WILLIAMSON COUNTY, TEXAS

CHANGE ORDER NUMBER: 1

Project:	<u>Forest North Phase 3</u>
Roadway:	<u>Drainage Improvements</u>
CSJ Number:	<u>3866</u>

Forest North Drainage Phase 3 Williamson County Project No. 3866

SHEET
C-106
9 of 75

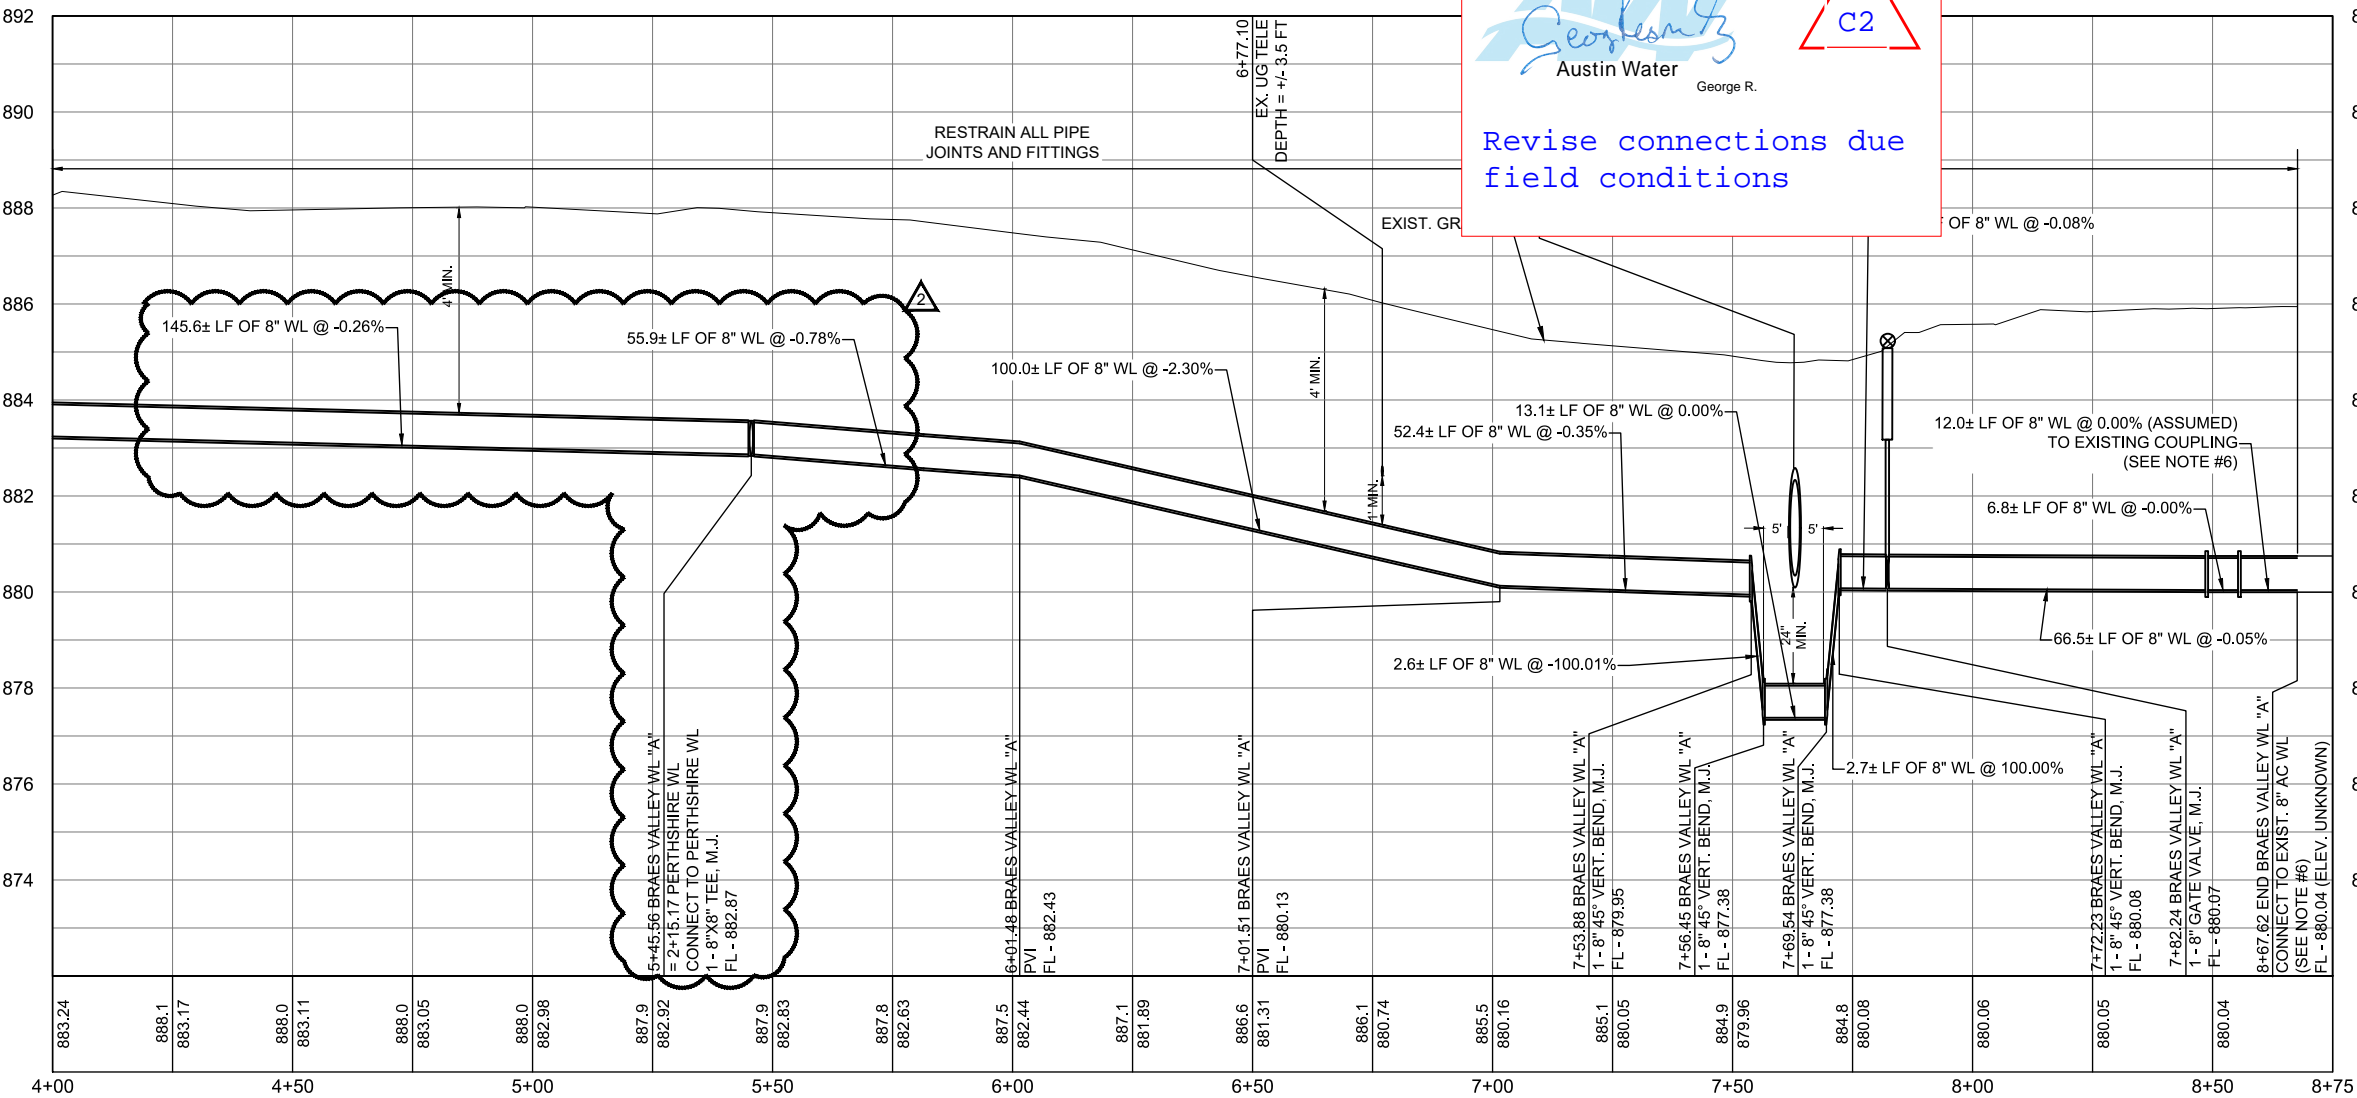
When potholing the existing water line on Perthshire Street, it was determined that the existing COA 6" water line is not in conflict with the proposed drainage structures as shown in the plans, therefore the length of the removal of the existing water line relocation will be reduced.

REV.	NO.	REVISION DESCRIPTION	DATE
1	1	CHANGED DESIGN DUE TO DR. CHANGE	2/10/2020
2	2	COMBINED BRAES VALLEY WL INTO ONE ALGN	3/18/2020
3	3	CHANGED PERTHSHIRE WL ALGN AND STATION	6/17/2020
4	4	DUE TO FIELD CONDITIONS

C-109

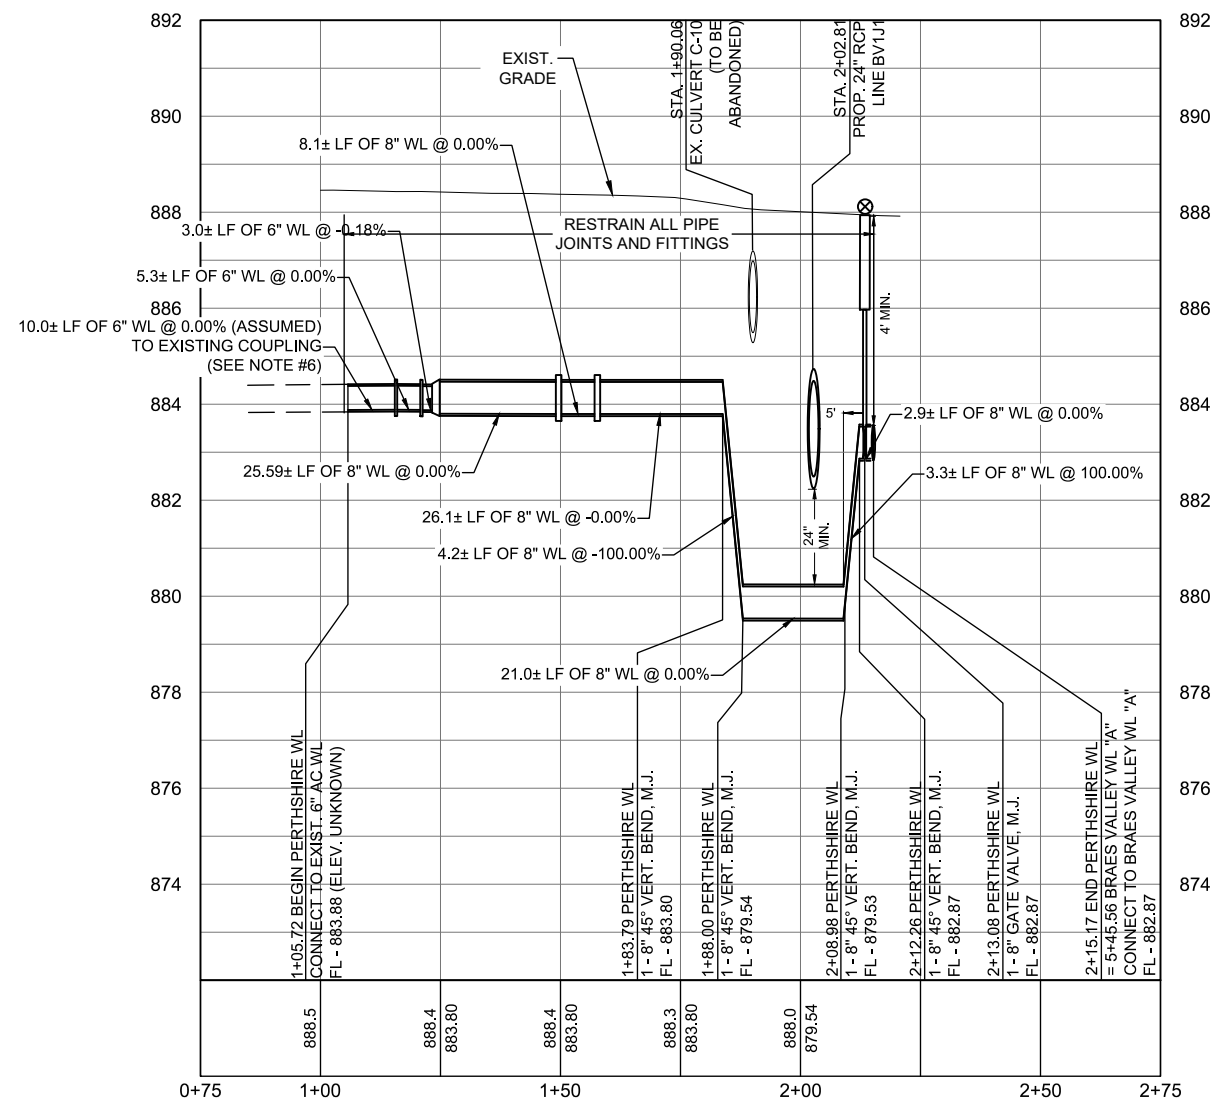
Revise connections due
field conditions
